# **RIDGEWOOD SUBDIVISION, RESUBDIVISION OF**

## **LOT 9**

APPLICATION NUMBER 8 DATE December 2, 2004

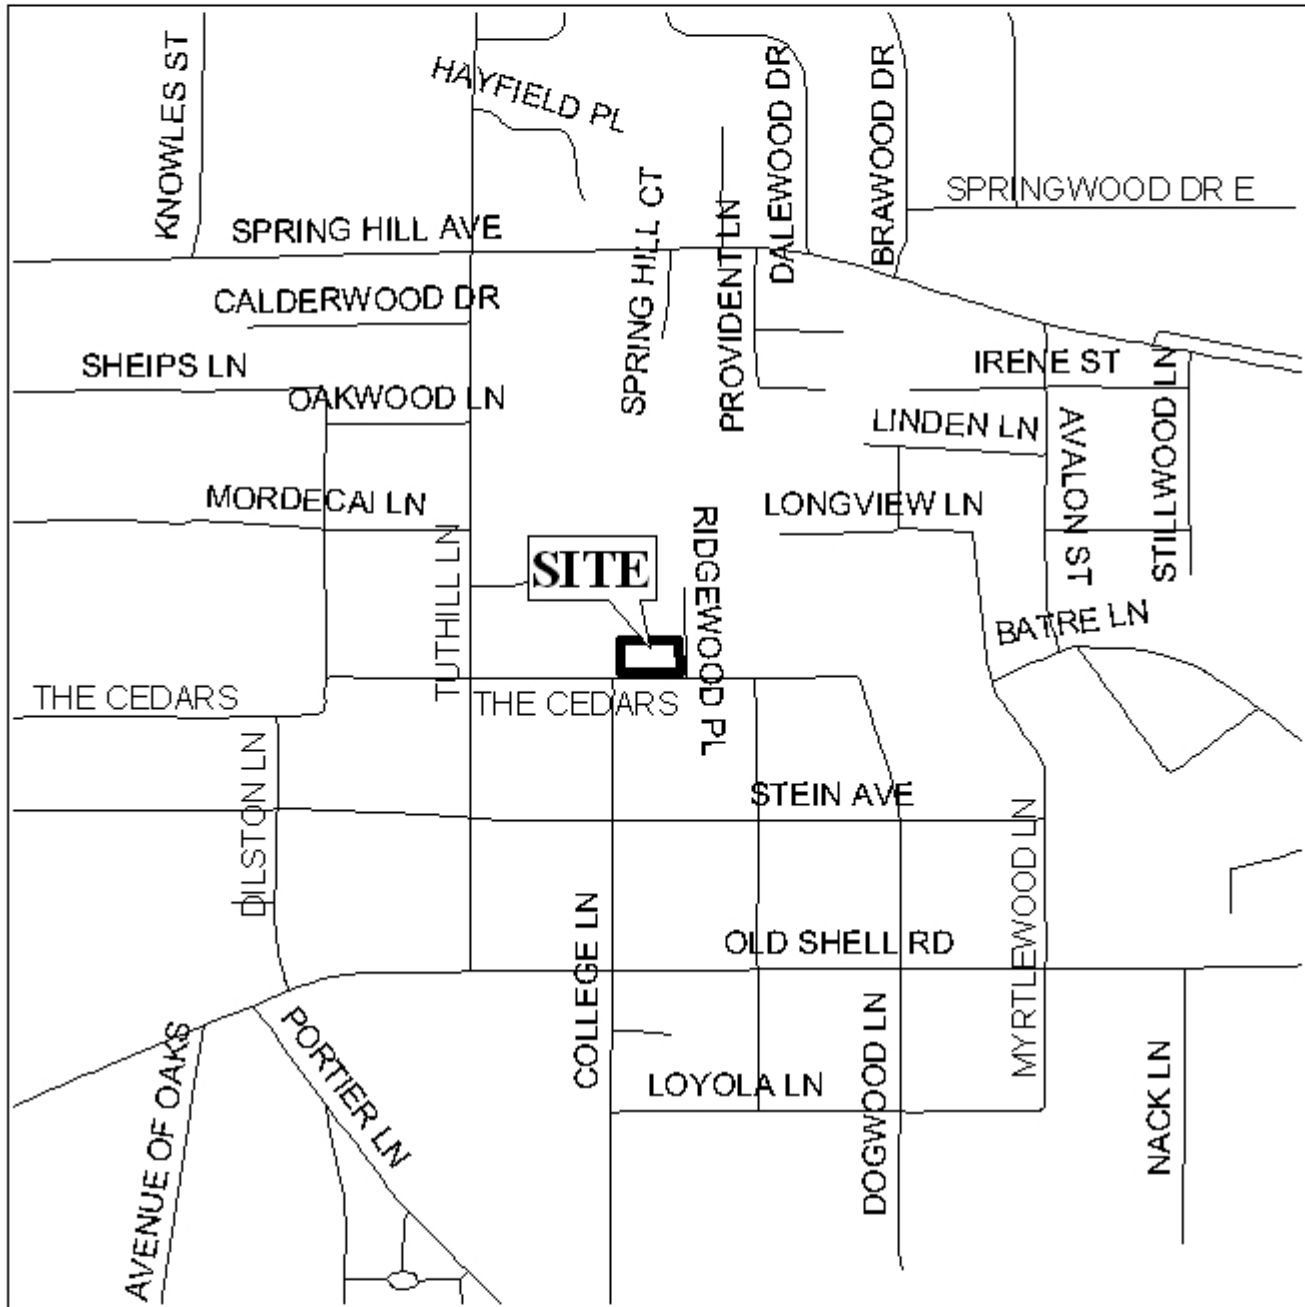
The plat illustrates the proposed 1 lot, 0.5  $\pm$  acre subdivision which is located at the Northwest corner of Ridgewood Place and The Cedars and is in City Council District 7. The subdivision is served by public water and sanitary sewer.

The purpose of this application is to reestablish side and rear yard setbacks for a previously approved Subdivision. The proposed setbacks meet the minimum requirements of the Zoning Ordinance.

The site is a corner lot, thus the dedication of a 25' radius should be required. It should be noted that a radius is not requested at The Cedars and College Lane, as College Lane is currently unimproved and would remain as such for the foreseeable future.

The plat meets the minimum requirements of the Subdivision Regulations and is recommended for Tentative Approval subject to the following condition: 1) the dedication of a 25-foot radius at the corner Ridgewood Place and The Cedars.
